# PENNDOT e-Notification

Bureau of Design  
Bridge Quality Assurance Division

No. 003  
December 2, 2002

### Consideration of Beam Notch for Draped Strand Designs

**END OF BEAM ELEVATION VIEW**

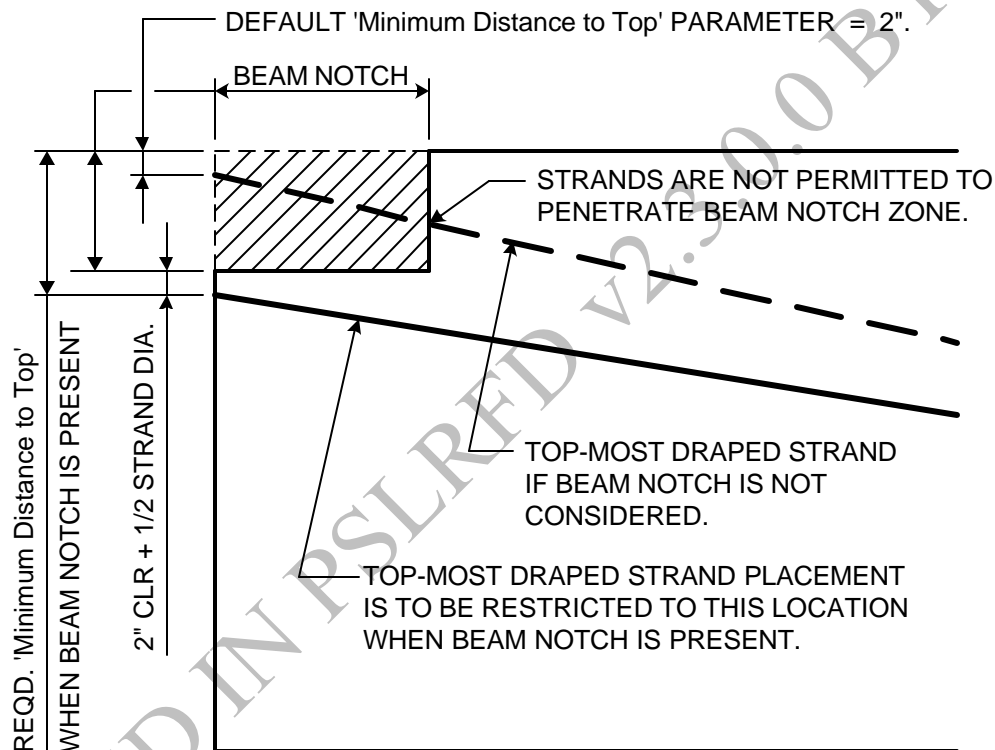
A problem has been identified recently that some designers are failing to consider the beam notch area when designing prestressed concrete beams with draped strand configurations. Due to fabrication difficulties, strands are not permitted within the depth of the beam notch.

To avoid unconstructable draped strand designs due to strands being located within the beam notch zone, enter the following value for Parameter 7 of the SCD command:

Refer to the sketch on the next page for details.

Minimum Distance to Top = standard beam notch depth + 2 inches clear + 1/2 the strand diameter
